Stormwater Upgrades - East Hants Aquatic Centre - RFC50841

Addendum 2

BASEMENT ELEVATION - NEW

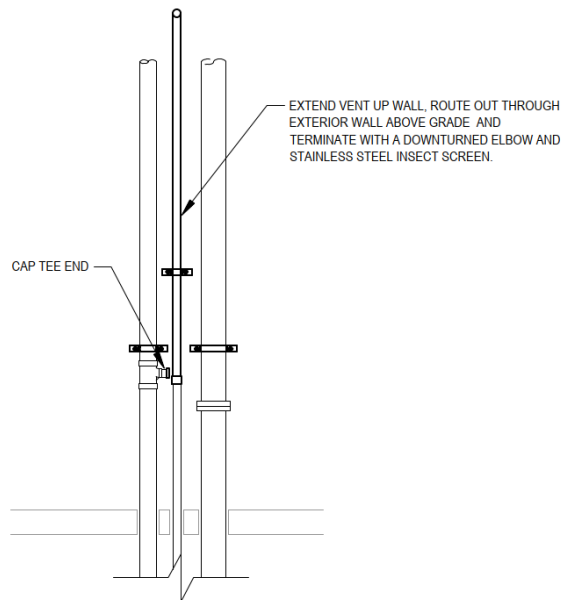
6. What size are these pipe?

Larger pipe at the tee is 4", vent line to be extended is 2".
